PUBLIC INTEREST REVIEW FOR GROUNDWATER APPLICATIONS

TO: Water Rights Section Date 08/06/2015  
 FROM: Groundwater Section Michael J. Thoma  
Reviewer's Name  
 SUBJECT: Application G- 18090 Supersedes review of \_\_\_\_\_  
Date of Review(s)

**A. GENERAL INFORMATION:** Applicant's Name: Valley Falls Farms LLC County: Linn

Figure 2: Application Map

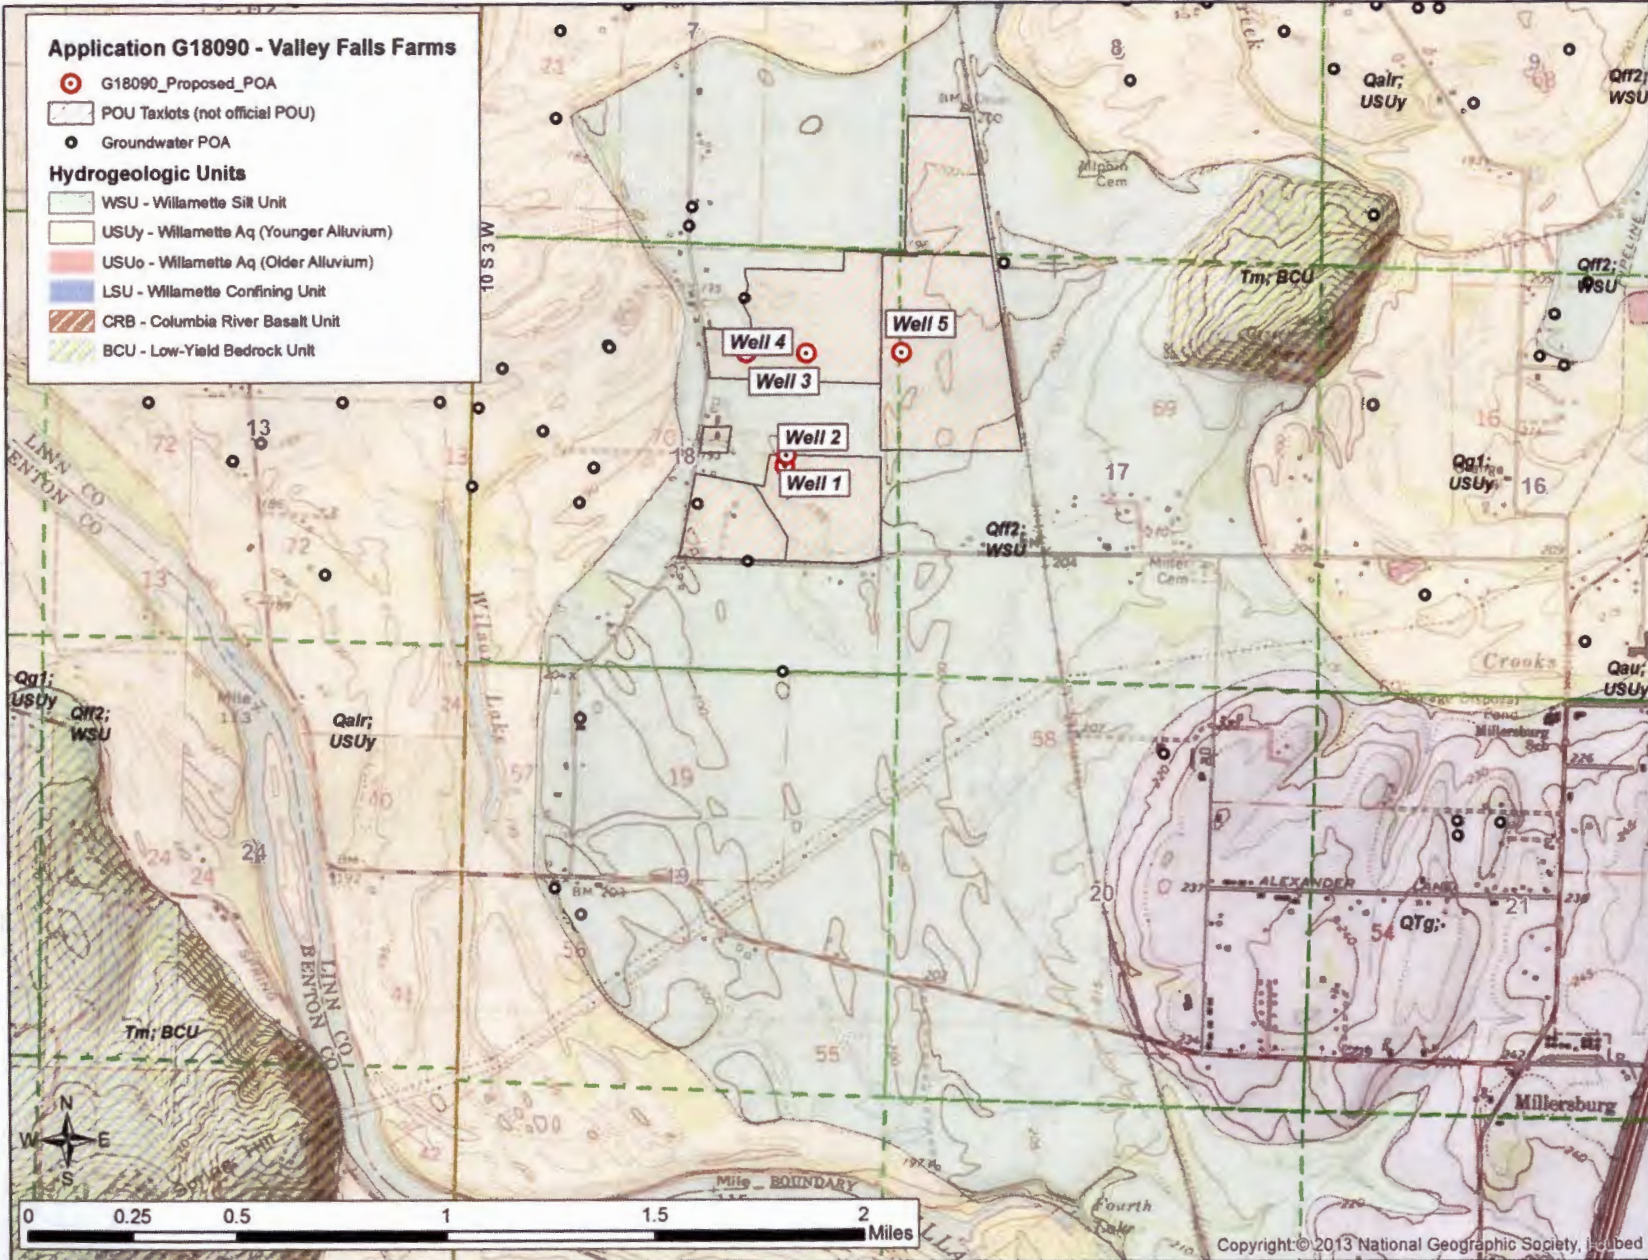
There are certificated water rights and numerous groundwater claims that have not yet been certificated near the applicant's proposed POU (including claims GR 1036 and GR 1732 which underlie part of the proposed POU) (Figure 2). Most POAs for these claims are shallow wells (< 50 ft total depth) that produce from the same coarse-grained sediments as the applicant proposes. The coarse-grained material is likely highly transmissive with relatively high specific yields. This type of

hydrogeologic setting implies that there will likely **not** be substantial interference between users, but standard interference conditions should still be applied if the permit is issued.
